Docket Items #13 & 14  
BAR #2018-00577 & 2018-00578

BAR Meeting  
January 16, 2019

**ISSUE:** Permit to Demolish/Capsulate (partial), Certificate of Appropriateness for alterations

**LOCATION:** 1106 and 1108 King Street

North Elevation

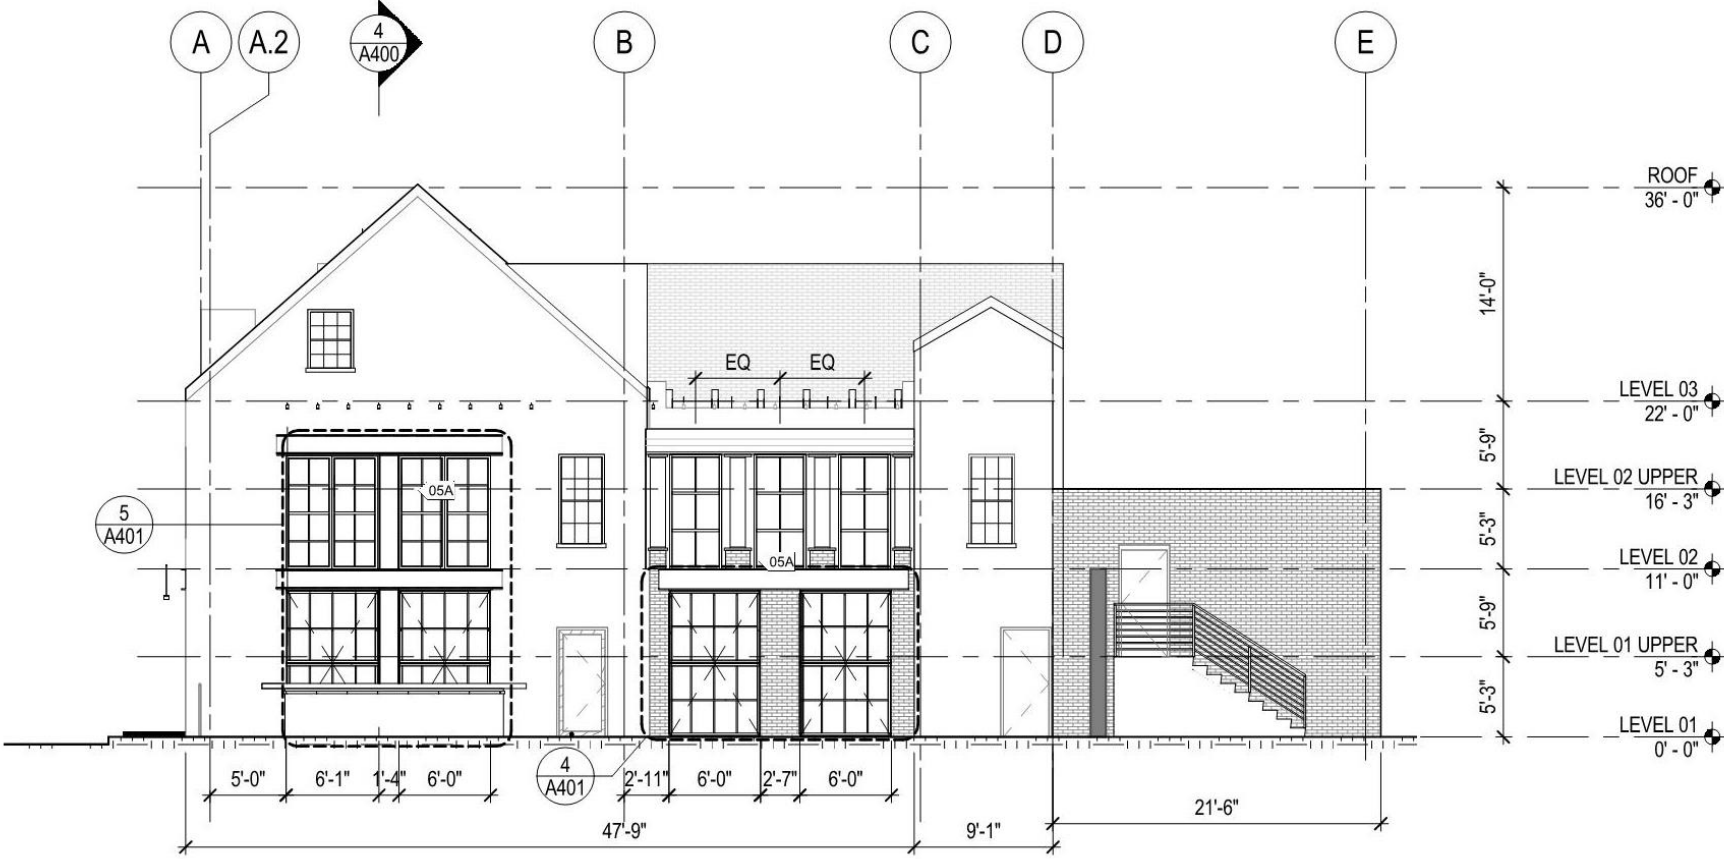
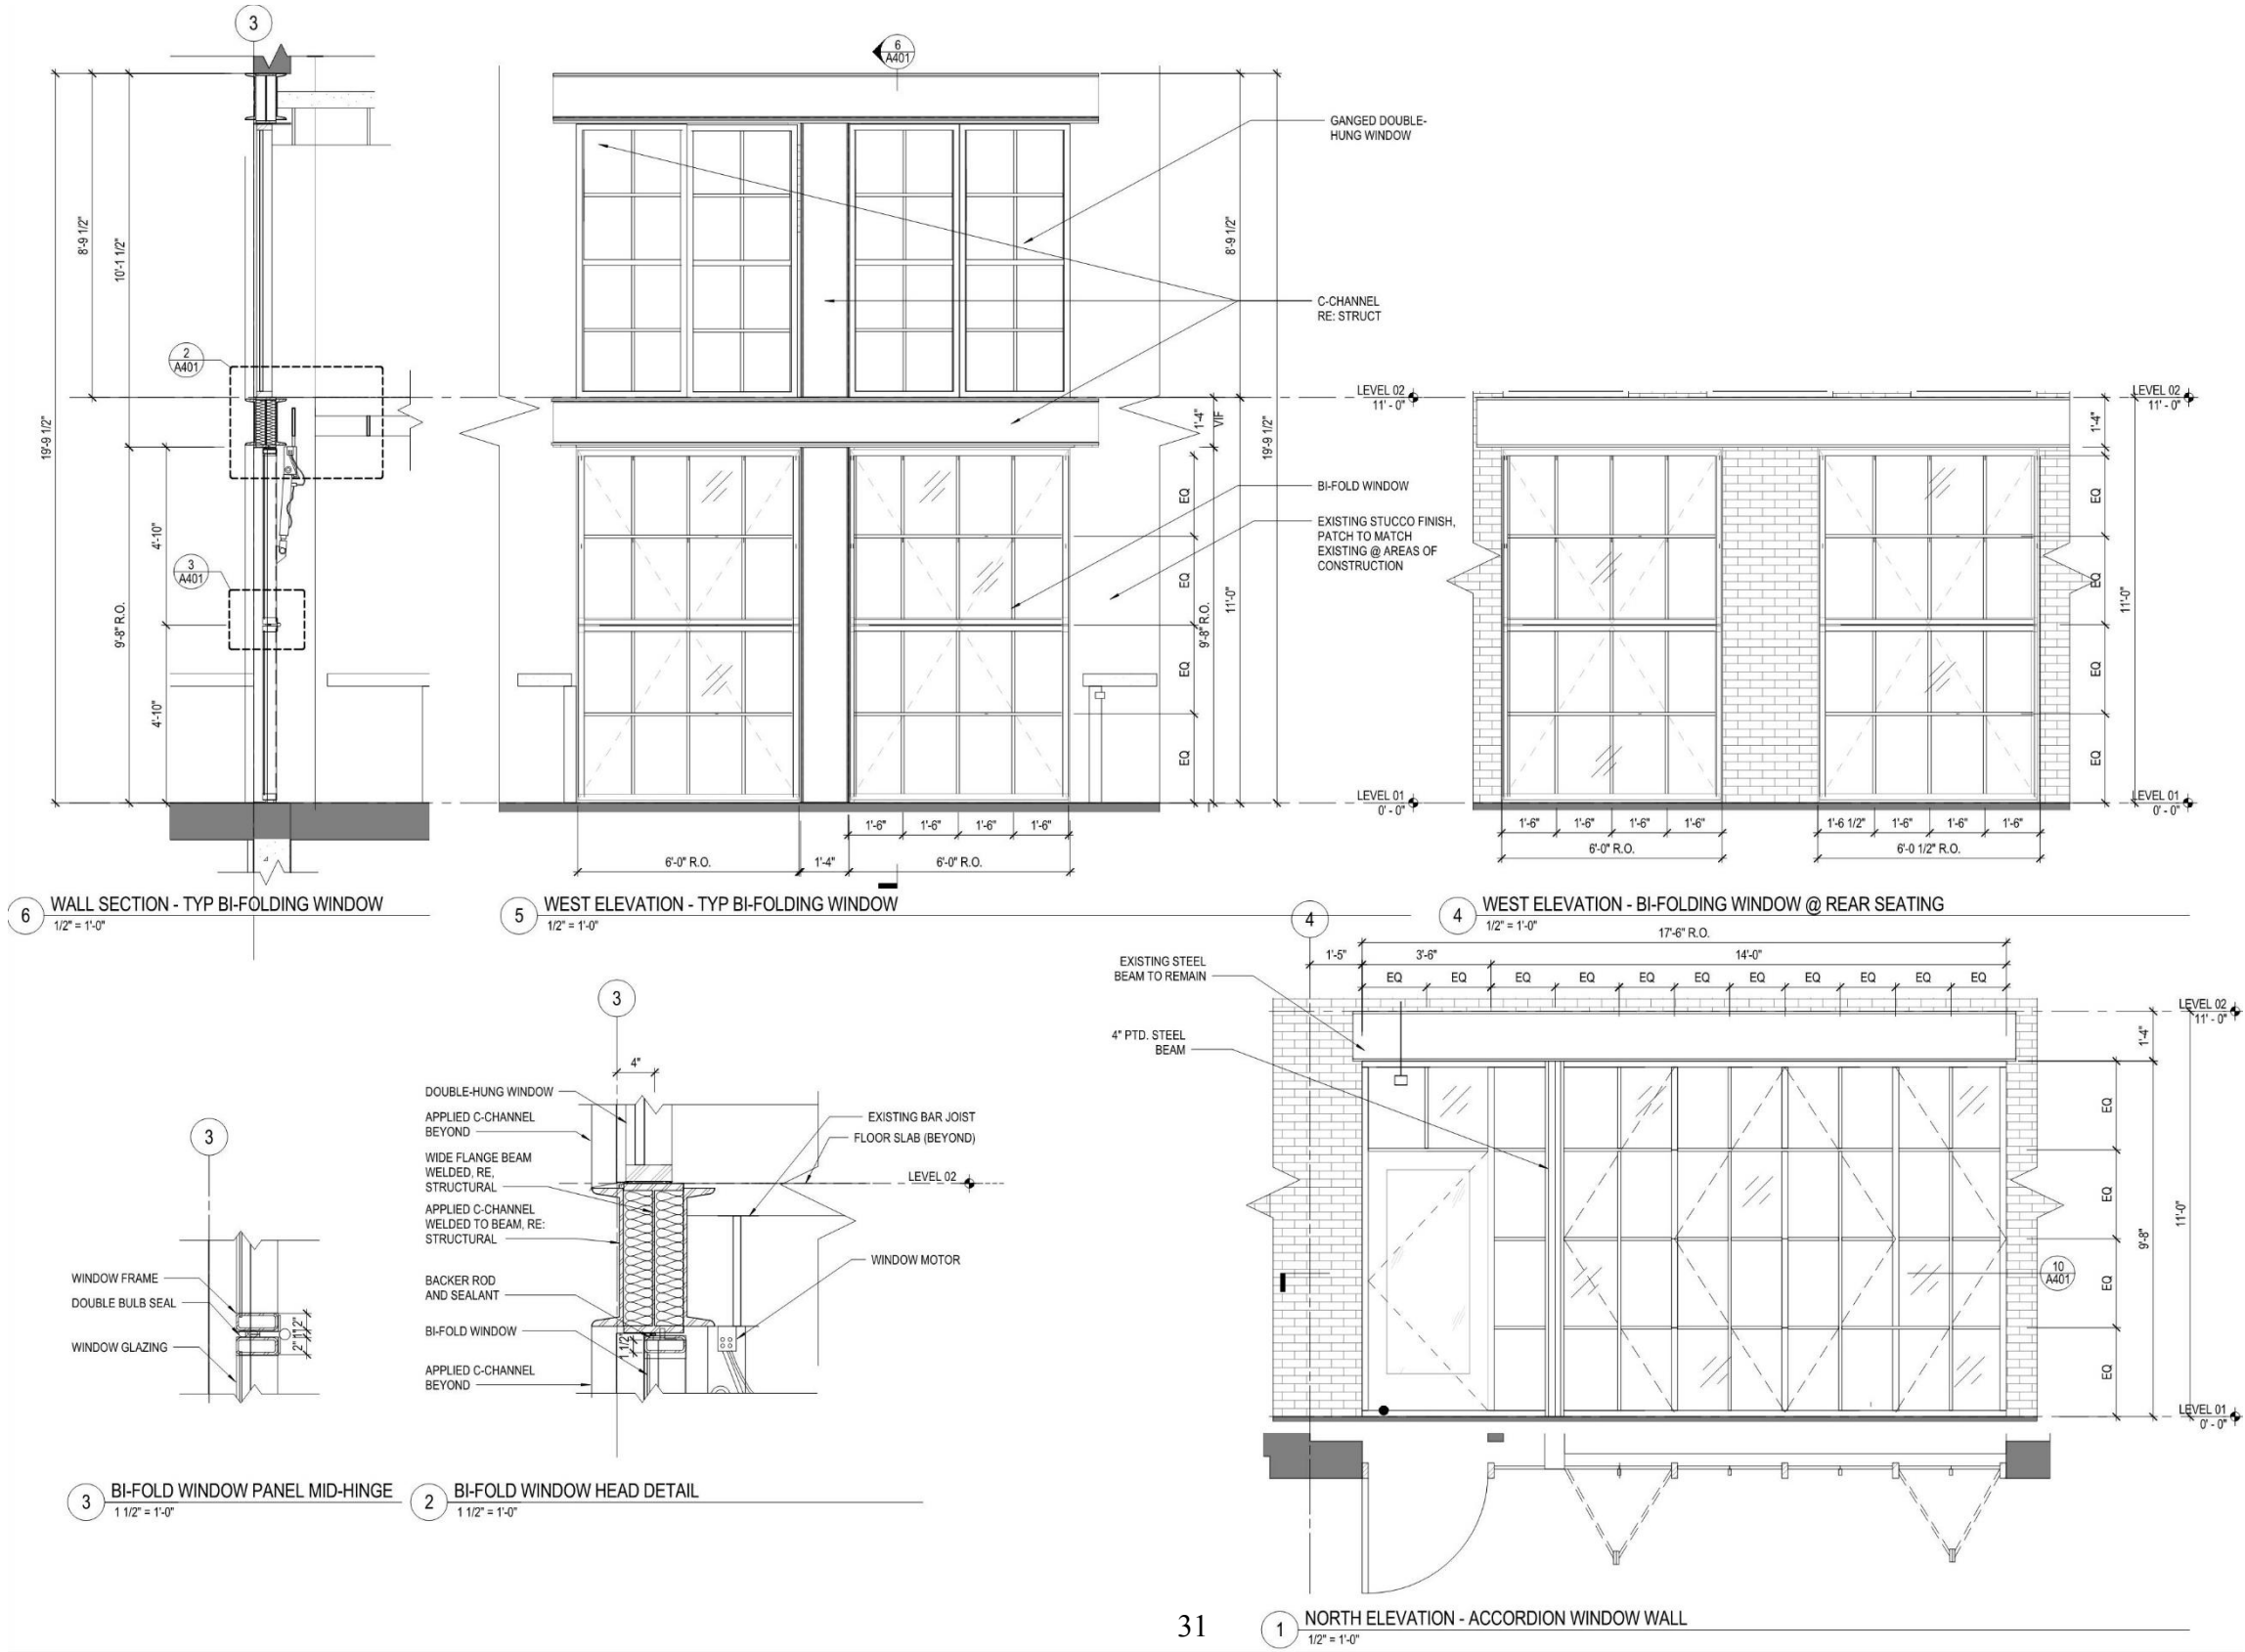
While staff supports the architectural character of the new storefront, it appears on the plans and renderings that both the primary and bi-fold doors on King Street project into the King Street right-of-way. This requires an encroachment ordinance from City Council and the Department of Transportation and Environmental Services generally does not support such encroachments on narrow, busy sidewalks such as King Street. Staff, therefore, recommends that the proposed storefront be recessed so that none of the doors on the facade project beyond the property line.

# Exterior Lighting – Reflected Ceiling Plan and Calculations

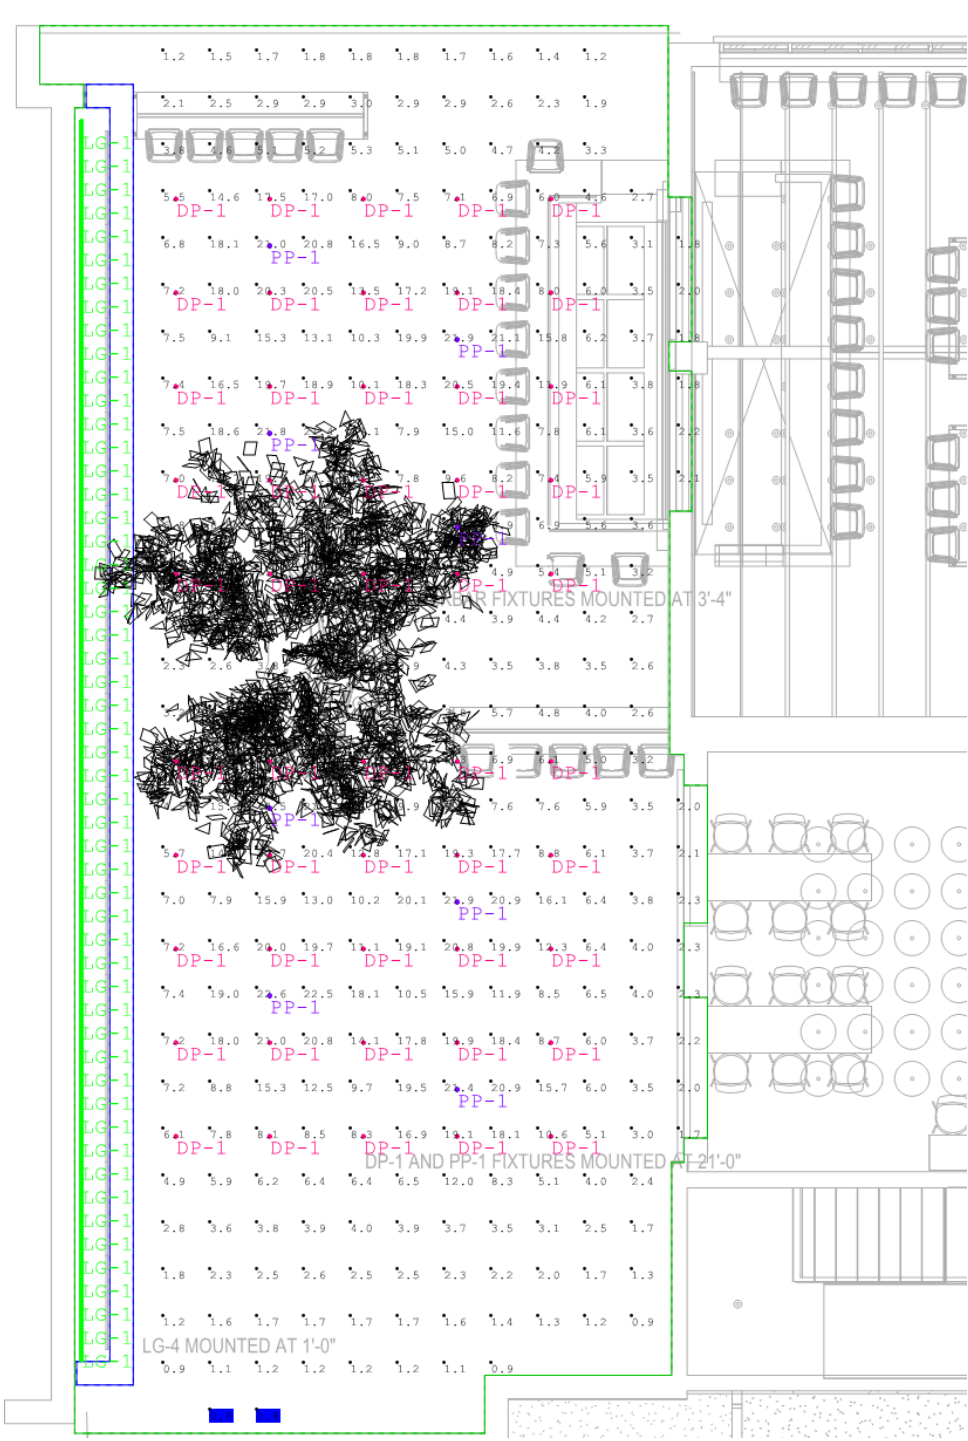
The issue of the color, or temperature, of LED lights has also been discussed by the BAR in the past few years as these energy efficient bulbs have become more popular and the consensus has been that the color of the LED lighting should be warmer (yellow) rather than cooler (blue) and have a temperature measuring no greater than 4000 Kelvin, with 3000 Kelvin preferred. Based on staff's recent experience with the replacement Gadsby street lights, the warmer light colors are now more widely available than they were several years ago and all of the new City street lights are expected to be 3000K, as requested by the BAR. The applicant's Luminaire Schedule indicates

that the projector image spots will be 3000K but information on the other LED bulbs was not provided.

The greatest concern in this case is the potential brightness of the lights relative to their context. The brightness of the bulb is measured in foot-candles or lumens. Staff requested, and the applicant has provided, a photometric lighting diagram and the average lighting level in the courtyard will be **8.15** foot-candles at grade, with a minimum of around one foot-candle at the rear of the courtyard and a maximum of 22 foot-candles in the middle of the courtyard under the projector downlights. These numbers seem excessively bright. The Alexandria Police Department typically requires a minimum of 5 foot-candles in a parking garage where the walls are painted white for public safety and an average of 2 foot-candles on a public sidewalk. However, because it is very difficult to fairly evaluate the light levels without also seeing the ambient light and, knowing that the plants, red brick walls and pavement will absorb a great deal of the brightness, the BAR has generally directed staff to make a final determination of appropriateness at night in the field once the lights have been installed to ensure that the lights do not overwhelm the historic building, cause the business to become the brightest building on the block or glare in the eyes of pedestrians and motorists. Fortunately, LED lights are dimmable, and the fixtures can be aimed so that the light projects downward and not beyond the property line on to residential property, per City Code.

1. The brightness of the lighting in the courtyard is subject to field inspection by staff to ensure that it does not overwhelm the historic building or its neighbors on the block-face;
2. The final color/temperature of courtyard and sign lighting must be warm (not cool/blue) and no greater than 3000 Kelvin;
3. Neither the accordion nor main entry doors on the front façade may not encroach into the King Street right-of-way; and,
4. Submit final signage drawings for staff approval if compliant with the BAR's Administrative Approval of Signs policy.
